Project	<b>IEEE 802.16 Broadband Wireless Access Working Group</b> < <a href="http://ieee802.org/16">http://ieee802.org/16</a> >	
Title	Clarification on UL CQICH SNR feedback for MIMO systems	
Date Submitted	<b>2005-03-11</b>	
Source(s)	Jianzhong (Charlie) Zhang, Anthony Reid, Kiran Kuchi, Heikki Berg, Nico Van Waes  Nokia Research Center 6000 Connection Drive Irving, TX 75039	Voice: 972-374-0958 Fax: 972-894-5937 <a href="mailto:charlie.zhang@nokia.com">charlie.zhang@nokia.com</a>
Re:	IEEE 802.16e D5 Draft	
Abstract	Proposes an improved channel quality indicator for vertically encoded MIMO systems	
Purpose	To incorporate the changes proposed here into the 802.16e D6 Draft.	
Notice	This document has been prepared to assist IEEE 802.16. It is offered as a basis for discussion and is not binding on the contributing individual(s) or organization(s). The material in this document is subject to change in form and content after further study. The contributor(s) reserve(s) the right to add, amend or withdraw material contained herein.

# UL CQICH SNR Feedback for MIMO Systems

Figure 229b – Post Processed S/N for MIMO

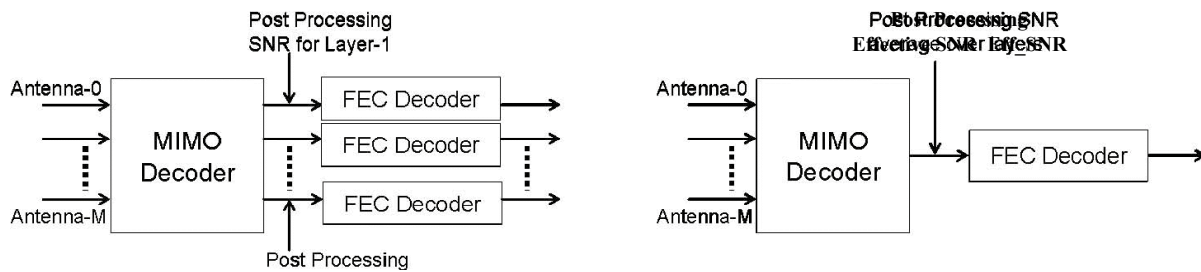
MIMO capable MS shall measure post processing S/N for each individual layers as shown in Figure 229b. When the FAST\_FEEDBACK subheader Feedback Type field is “00”, the MS shall report the post

processing Effective SNR (Eff\_SNR) as defined below. When BS requests MS feedback through CQICH\_Alloc\_IE() or CQICH\_Enhanced\_Alloc\_IE() with '00' Feedback\_type field, MS shall report Eff\_SNR or individual layer S/N as described in 8.4.5.4.12 and 8.4.5.4.15
